**N & S Aeration Lagoons  
Closure Certification Report**

**RE: NOTICE OF DISAPPROVAL  
FINAL CLOSURE PLAN NORTH AND SOUTH AERATION LAGOONS  
WESTERN REFINING SOUTHWEST, INC., BLOOMFIELD REFINERY  
EPA ID # NMD089416416  
HWB-WRB-10-007**

The New Mexico Environment Department (NMED) has reviewed Western Refining Southwest, Inc., Bloomfield Refinery (Western) *Final Closure Plan North and South Aeration Lagoons* (Closure Plan) dated May 2010. NMED hereby issues this Notice of Disapproval (NOD). The Permittee must address the following comments.

Re: Response to March 24, 2010 NOTICE OF DISAPPROVAL  
North and South Aeration Lagoons  
Closure Certification Report  
Western Refining Southwest, Inc., Bloomfield Refinery  
EPA ID# NMD089416416  
HWB-GRCB-09-007

**SAMPLE LOCATION MAP  
BLOOMFIELD REFINERY**

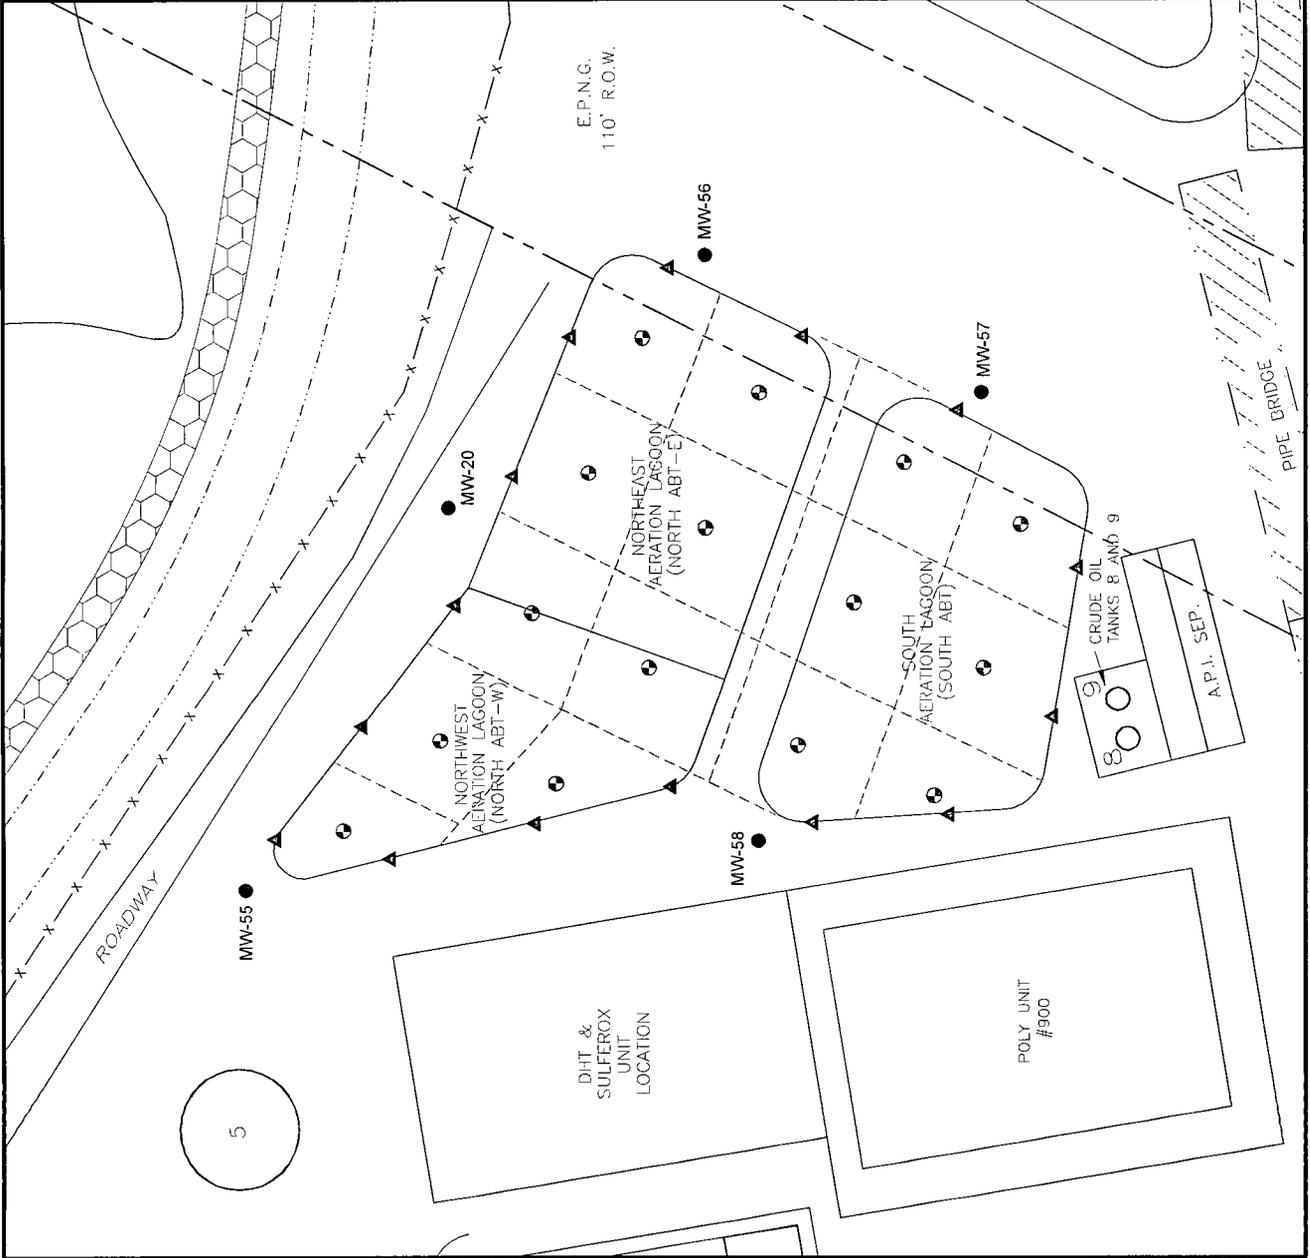
In Section 4.2.7 (Chemical Analyses), page 21, Western states “[s]oil samples will be analyzed by the following methods...” In the revised Closure Plan, Western must clarify if the methods also apply to the sludge/sediment samples as described in Section 4.1.1 or only the soil samples that will be collected from the borings and excavation limits shown in Figure 3 (Sample Location Map).

North and South Aeration Lagoon Map

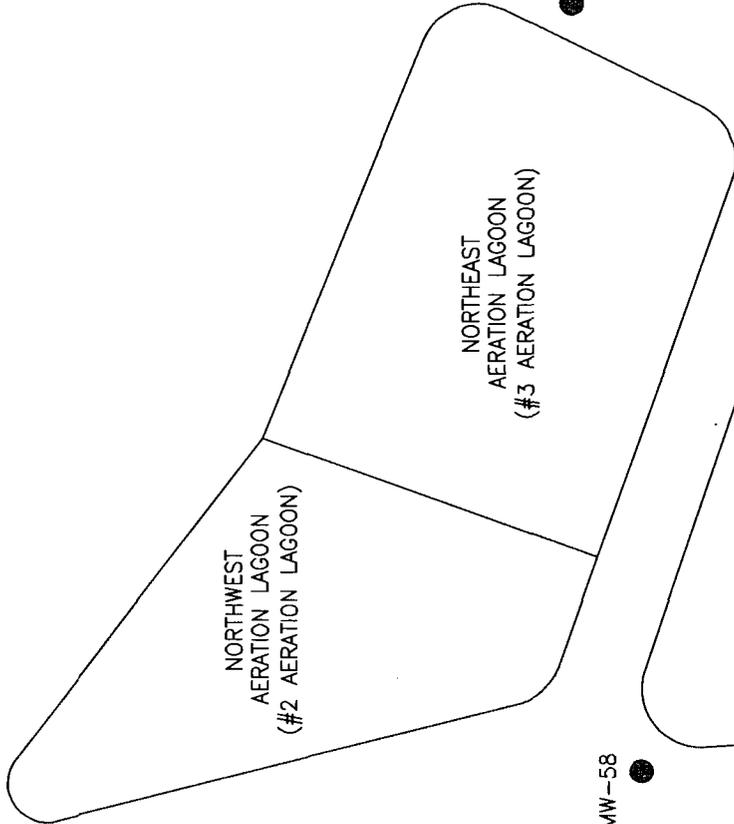
*In Section 4.1 (Sludge Characterization, Removal, and Disposal) on pages 5 and 6, Western references the aeration lagoons as follows: South Aeration Lagoon (#1 Aeration Lagoon), the Northwest Aeration Lagoon (#2 Aeration Lagoon), and the Northeast Aeration Lagoon (#3 Aeration Lagoon). The Report does not include a figure that identifies each aeration lagoon by name. Western must submit a figure that labels the aeration lagoons as described above.*

A figure labeling the aeration lagoons as described above is provided (**Attachment A**).

Figure 1  
Proposed Monitoring Well Locations

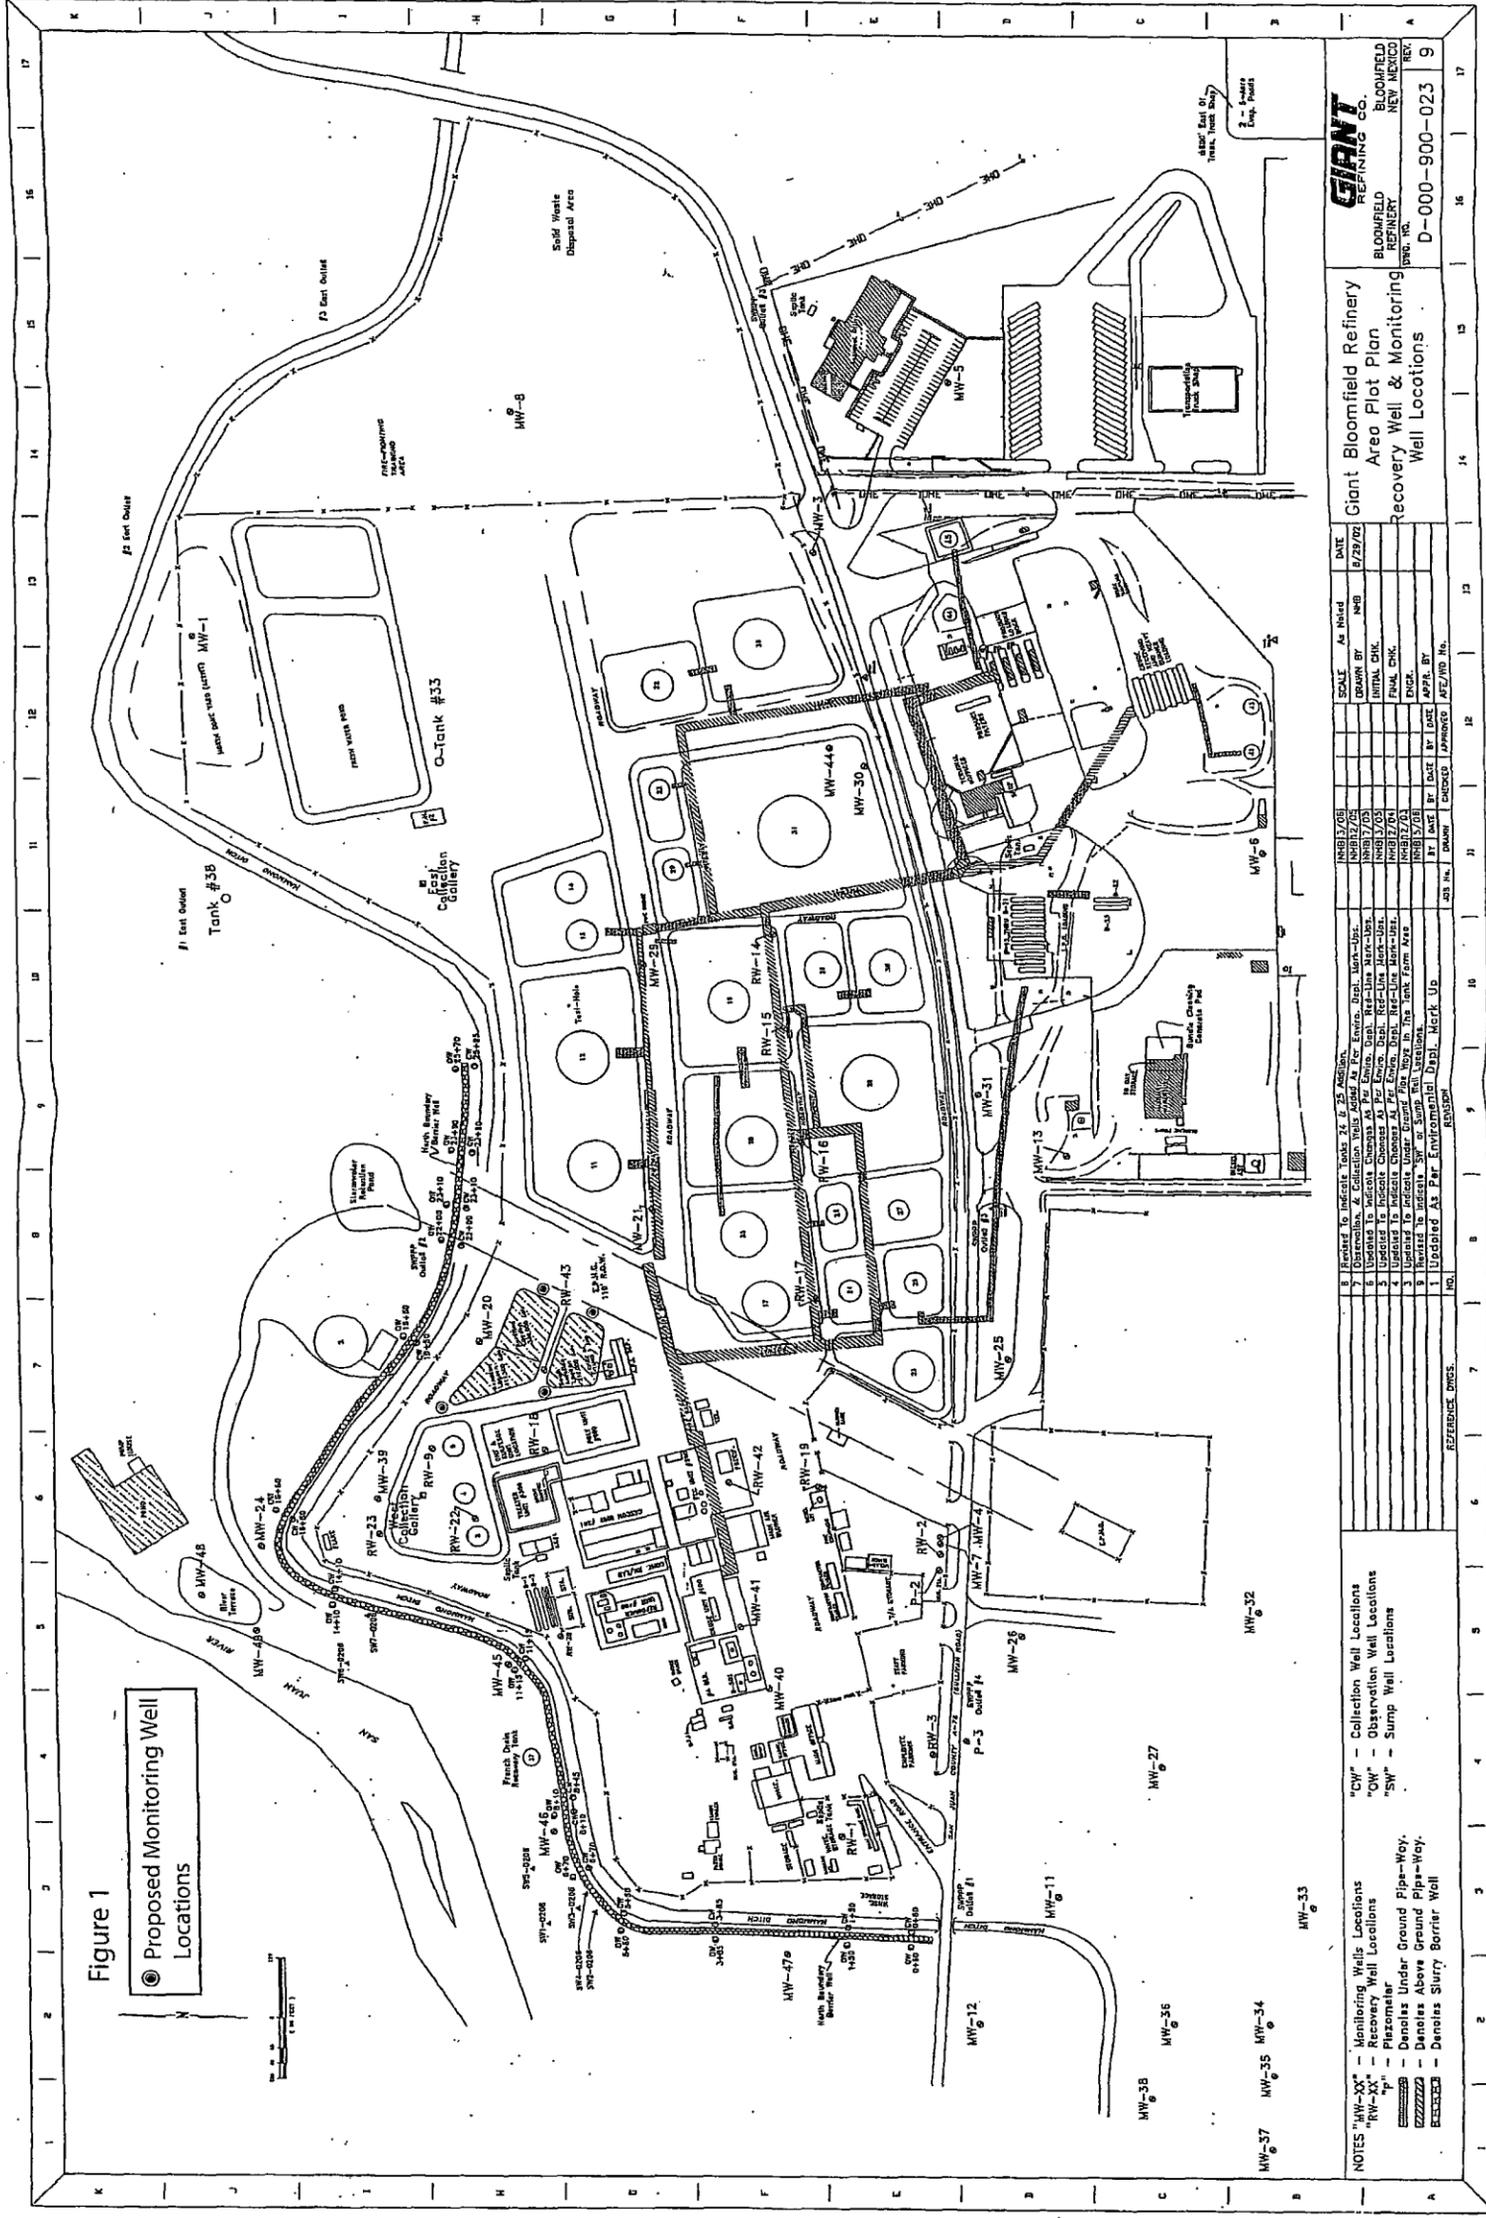
As part of the closure process, Western must install the four monitoring wells at the locations identified in the attachment Figure 1 (refer to 40 CFR 264.112(b)(5)) and must adhere to the following:
